**Subject: P.H.O. APPLICATION NO. PHO-1-24--Z-22-23-4** – Notice of Pending Actions by the **Planning Hearing Officer**

APPLICATION NO: PHO-1-24--Z-22-23-4

**Reason for Request:** Request to modify Stipulation 16 regarding landscape area.; Request to delete Stipulation 18 regarding right-of-way dedication for 8th Street.

Subject: PHO Written Request

**ENLARGED SITE PLAN**

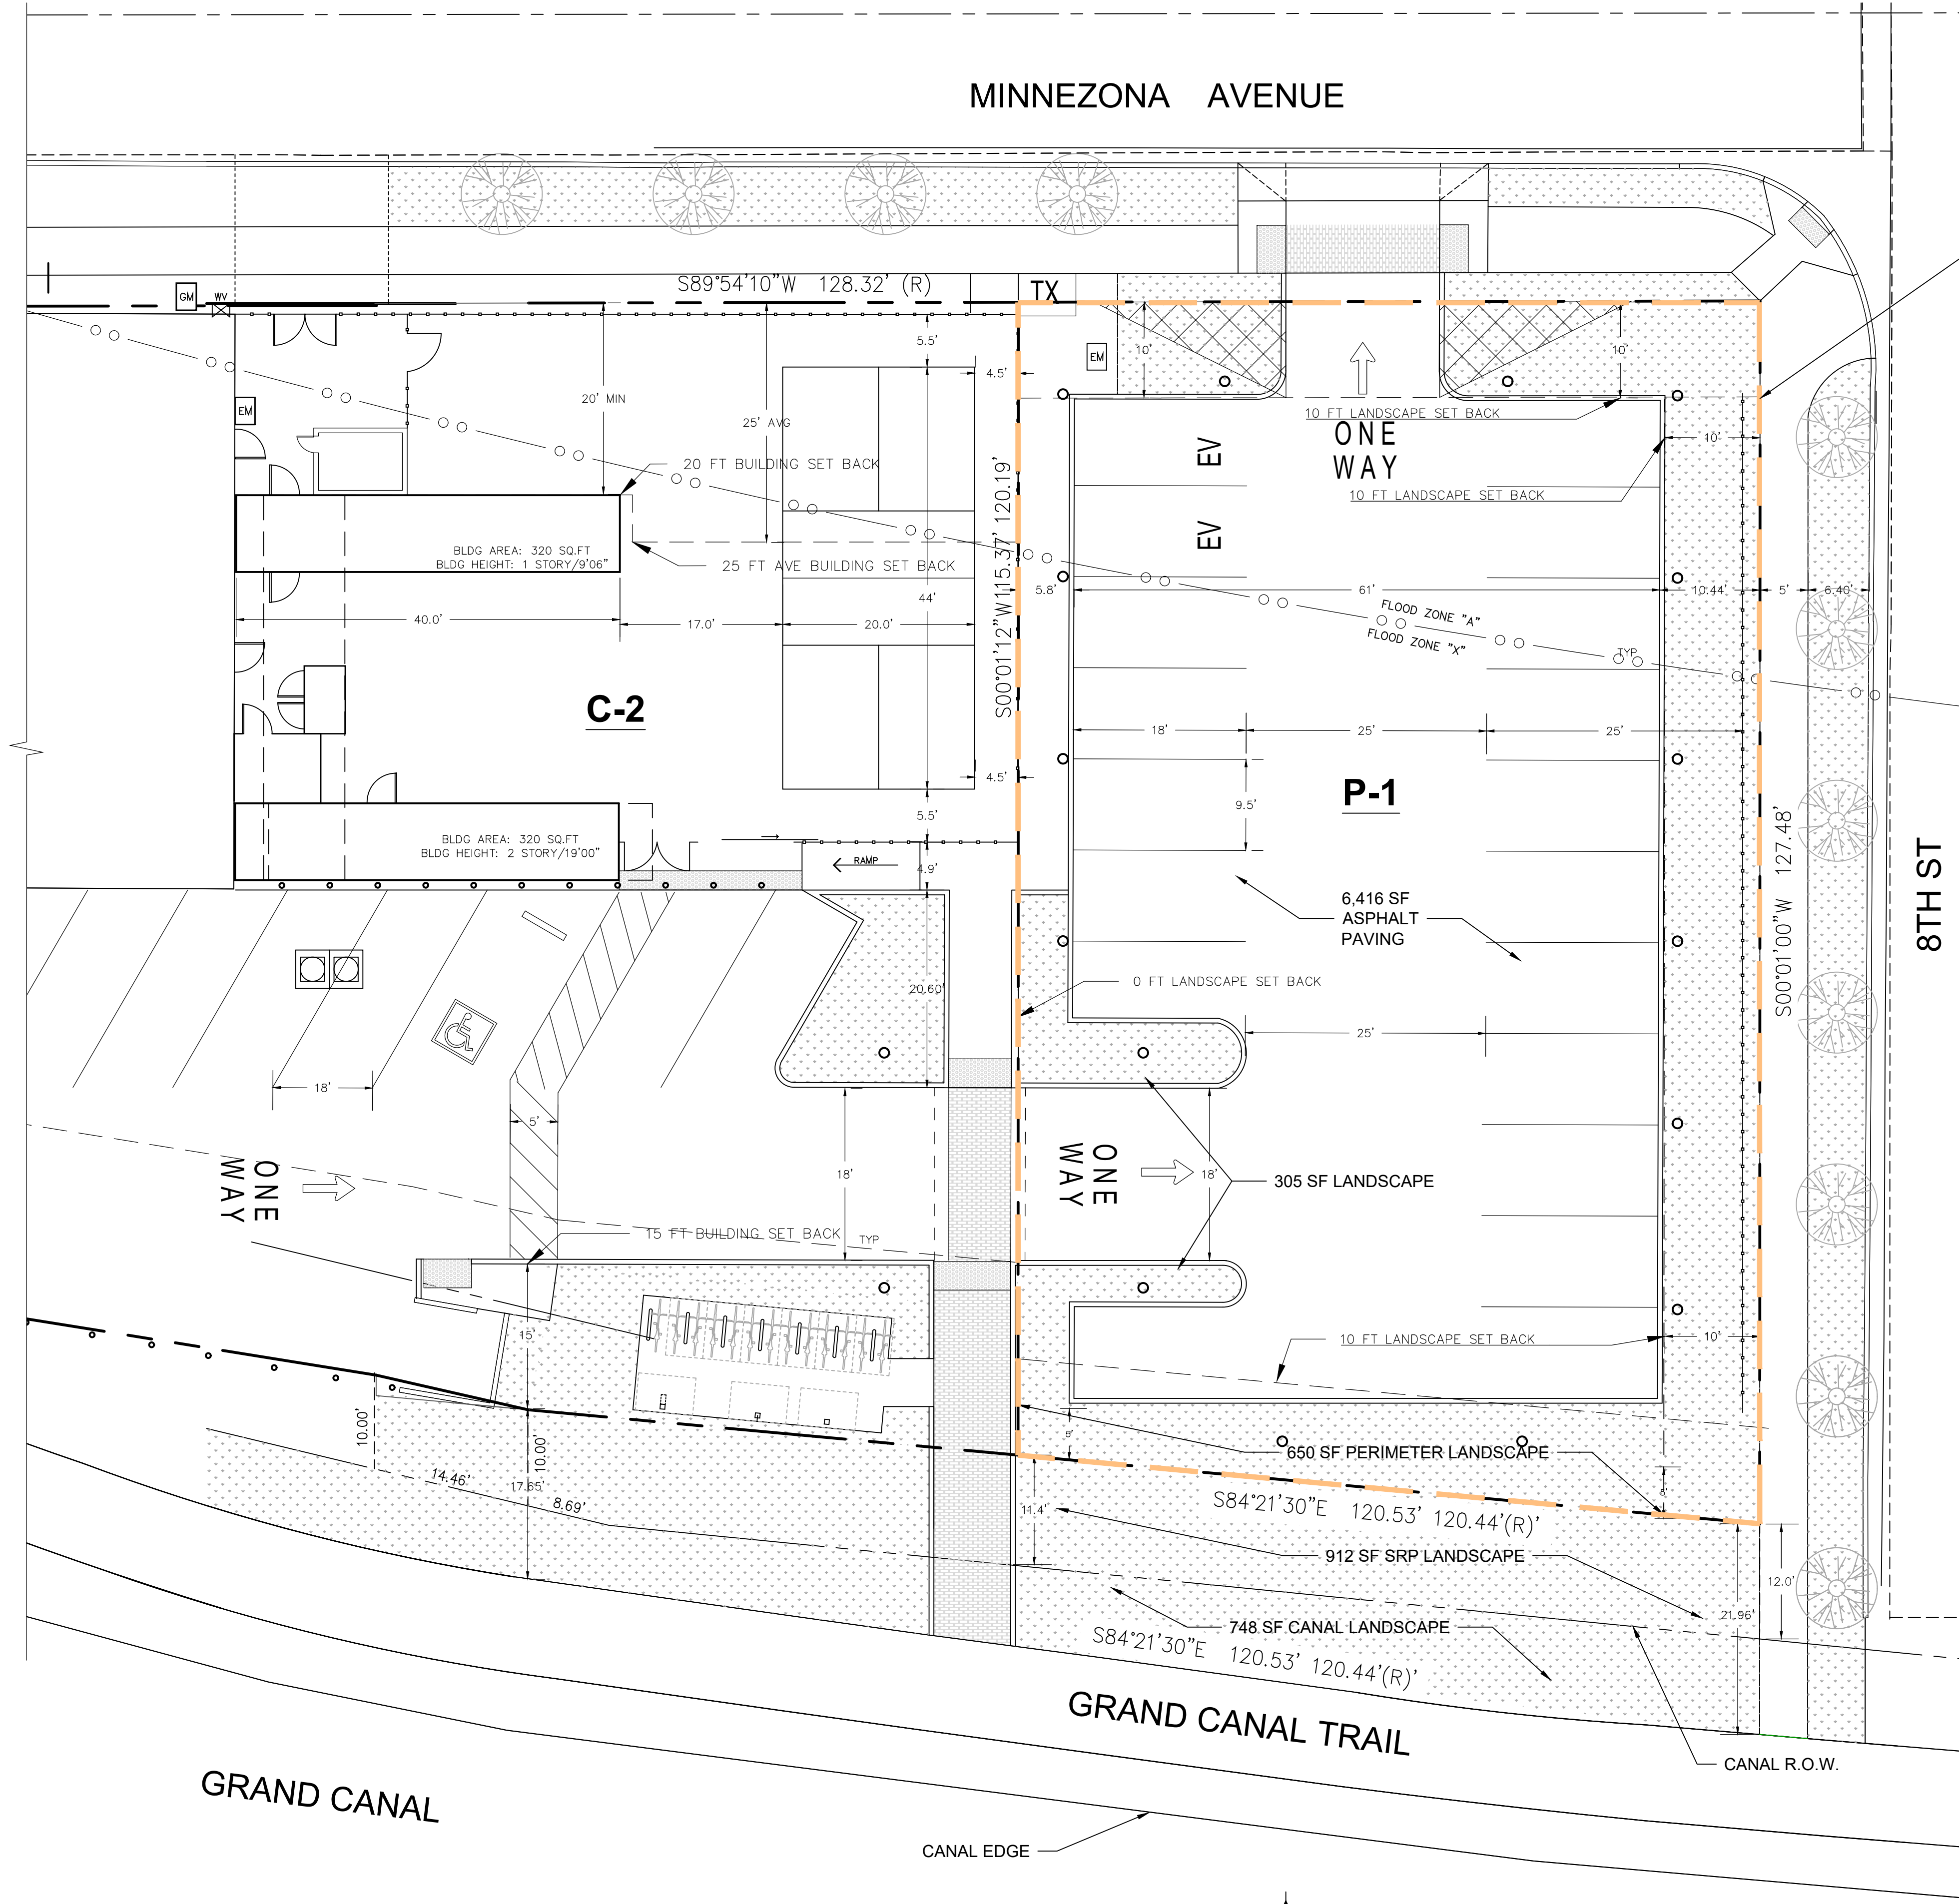
- 16. A minimum 5, average 10-foot-wide landscape ~~setback~~ **area** shall be provided from the south property line.

It is requested that stipulation 16 be modified to a landscape requirement that is not classified as a "setback" due to the extreme limitations placed upon landscape setbacks for development. It must be noted that the applicant is not opposed to providing landscape, but is promoting that the landscape count towards meeting stipulation 17 and other site development requirements required.

~~18. Right-of-way shall be dedicated for the west half of 8th Street for a half-radius 45-foot radius cul-de-sac dedication at its southern termination.~~

There is concern that Stipulation 18 does not appear feasible and conflicts with stipulations 14, 15, and 16.

The dedication will not only negatively impact the design of a sensible parking lot in P-1, but the actual completion of a 90' diameter cul-de-sac presents a major impact to the residents on the east side of 8<sup>th</sup> Street if it were to be built (See Enclosure 2). The city currently does not have a dedication of the other 45' half-radius required from the three lots to the east of 8<sup>th</sup> Street.

Furthermore, the cul-de-sac dedication at the termination of 8<sup>th</sup> street presents a conflict with property rights of the Salt River Project (SRP) who own the southern sliver of land. Enclosure 3, Sheet 2 shows that a portion of the requested

dedication will encroach on SRP property to include city improvements around the cul-de-sac.

It is proposed that this stipulation be deleted contingent upon the lot-line adjustment and replat to bring 8<sup>th</sup> Street in conformance with a maximum of 4 total lots on a dead-end street.
